# Century Apparels Ltd. (11059)

18.AUGUST.2014

# Identified Priority 3 Concerns

Typical Floor plan

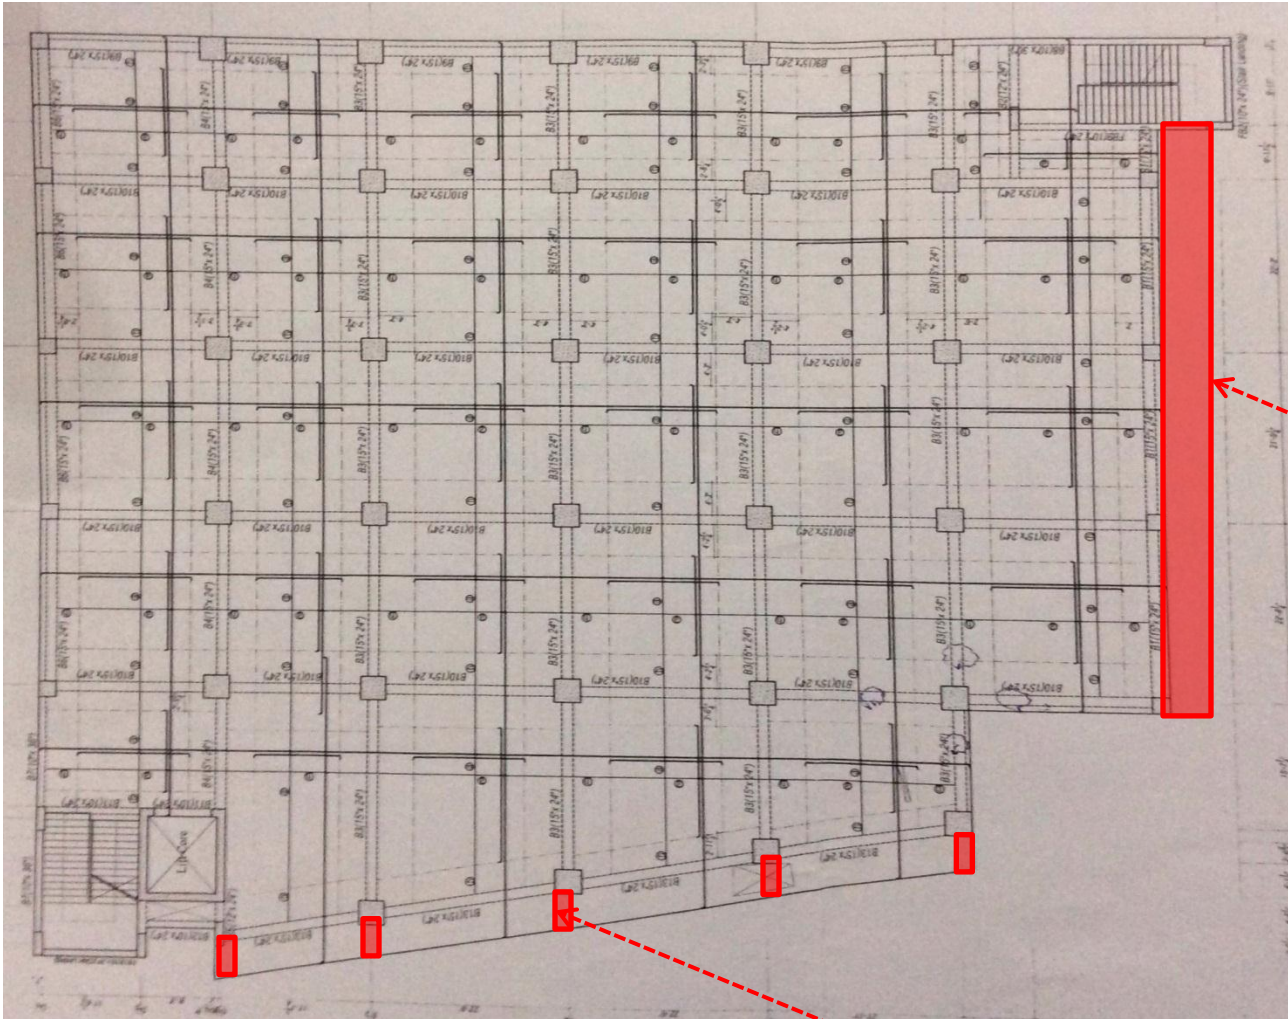
Extra cantilevered beams and slabs were not shown on the construction drawings

these cantilevered beams were not shown on the construction drawings.

The As-built drawings need to be revised to represent the actual existing construction.

### 3<sup>rd</sup> Priority 3 Concern

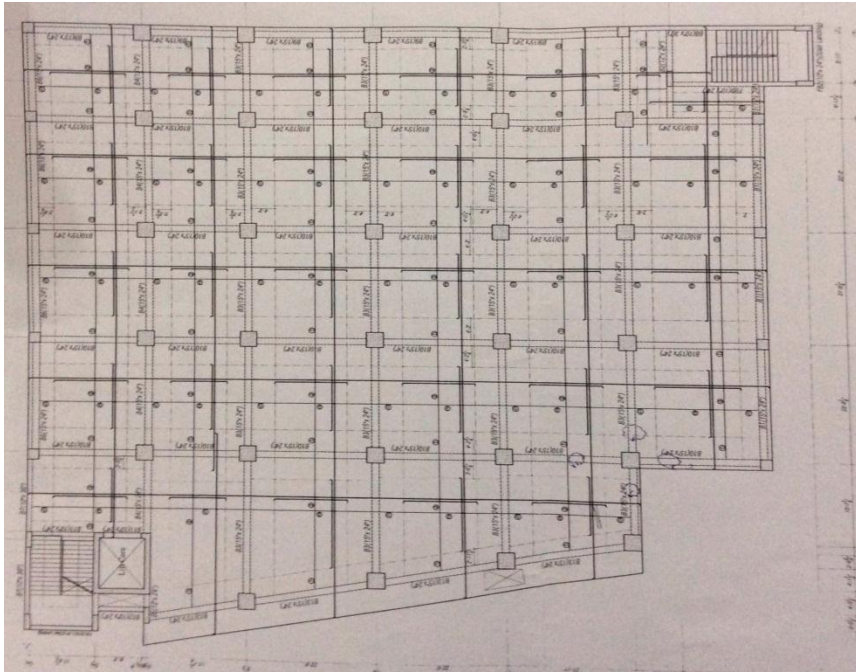
The roof needs to be protected with a water proofing layer if the construction does not proceed in the near future, (within 6 months).
